### Report to **Development Permit Panel**

Re:

Application by Matthew Cheng Architect Inc. for a Development Variance

Permit at 9700 No. 3 Road

#3c

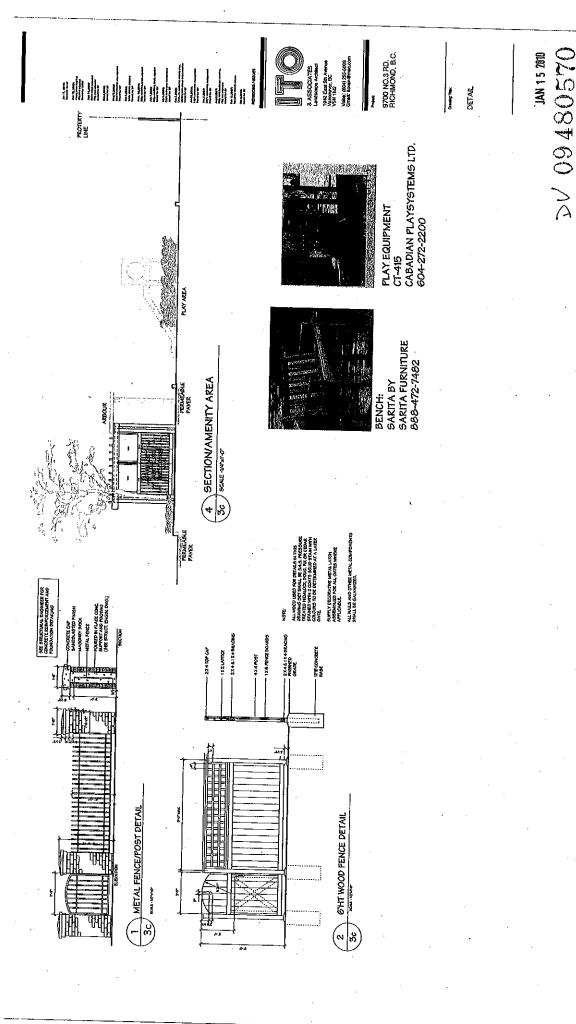
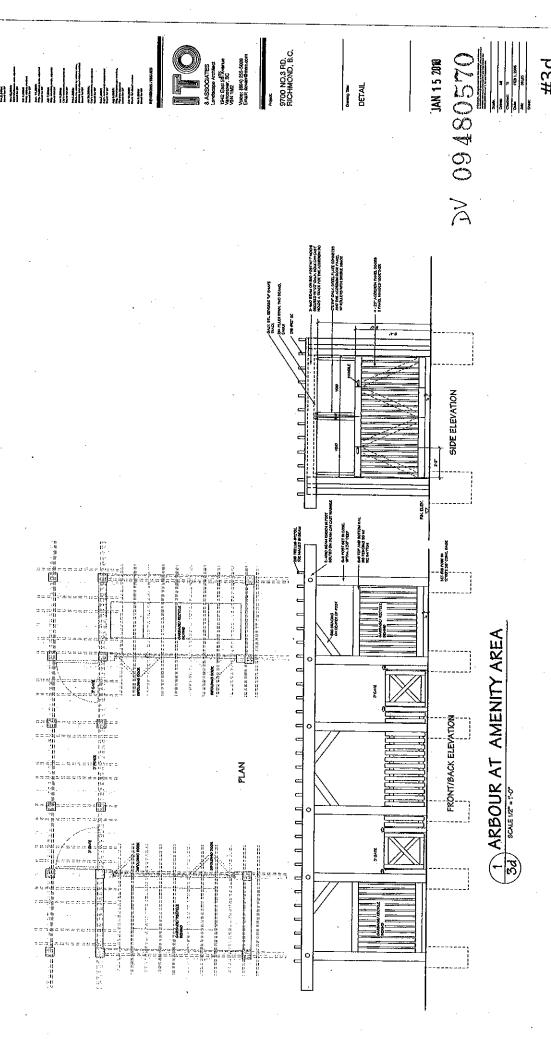
The following plants have been modified since previously approved plan for DP All the changes were made in the plating bed facing No. 3 Road. These plants are reflected in the plant list shown on sheet #3b

- -1. Acer palmatum (AP)
- 11. Picea omorica (PCO) have been increased in size from 3.5mht to 4.0mht.

in conclusion, total 11 trees have been increased in size from 3.5m to 4.0mht. four 1m.ht. Rhododendron, two #3pot, twenty one#2pot, fifty five10cm pot has been added. one 8cm tree, and 20. #1 pot has been decreased as result of available area.

INISH MATERIAL & COLOURS PPICAL FOR ALL ELEVATIONS

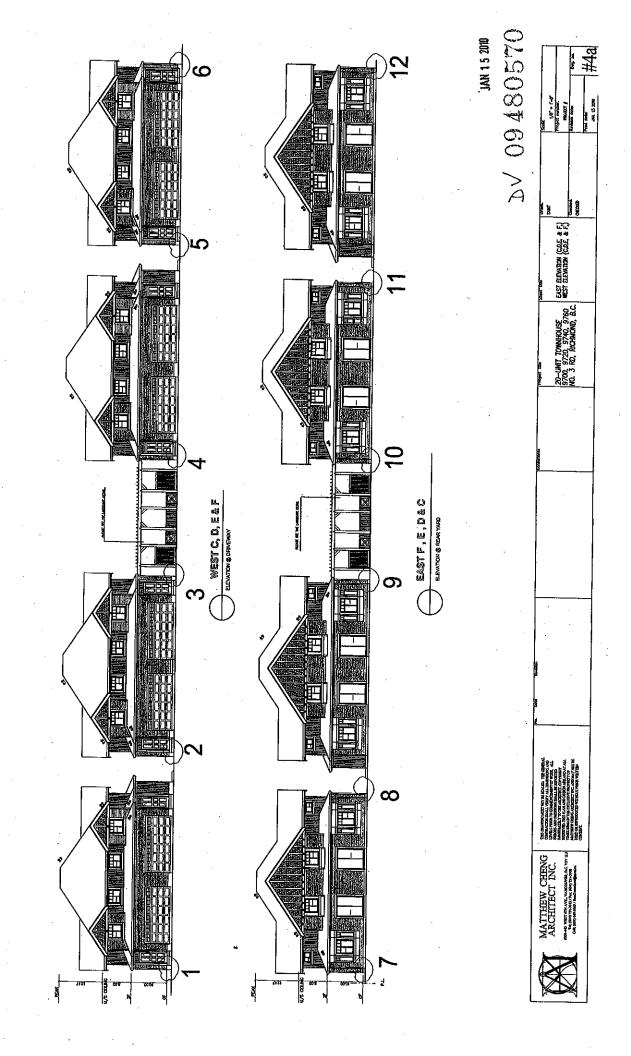
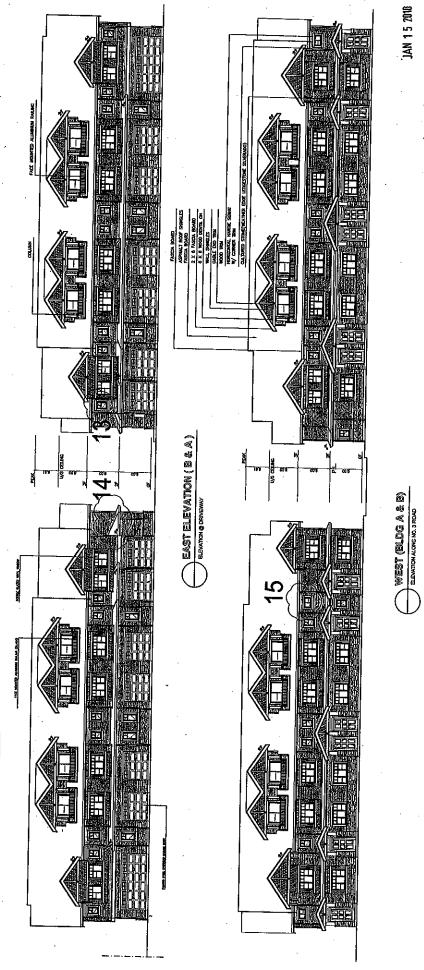
1. Each change is bubbled and numbered on the plans and a corresponding comment is provided on the written rationale.

No.1 to 12: The Foundation of the fireplaces was omitted in the DP set. They are corrected.

No.13: Window was added to balance the elevation.

No.14: There was a drafting error in the DP set. The slope of the roof should be shallower to match the rest of the building.

No.15: The window was changed from 2030 to 3020 since 2030 is too low for window to bathtub.

No.16 to 18: The foundation of the fireplace was omitted in the DP set. It is corrected.

No.19 to 20: The window has been changed from 3030 to 3020.

No.21a & 21b: The window was mirrored by mistake and is corrected.

N0.32a / 32b &32c trim has been change from more trim to single

No.23 to 24: The window has been changed from 3030 to 3020.

No.25 to 27: The foundation of the fireplace was omitted in the DP set. It is corrected.

No.29: Instead of placing the window above the bed, 2030 windows are proposed on either side of the bed for better interior layout.

No. 30: There was a drafting error of this unit in the DP set. The slope of the roof should be shallower to match the rest of the buildings.

No.31 There was a drafting error of this unit in the DP set. The slope of the roof above mail box is corrected
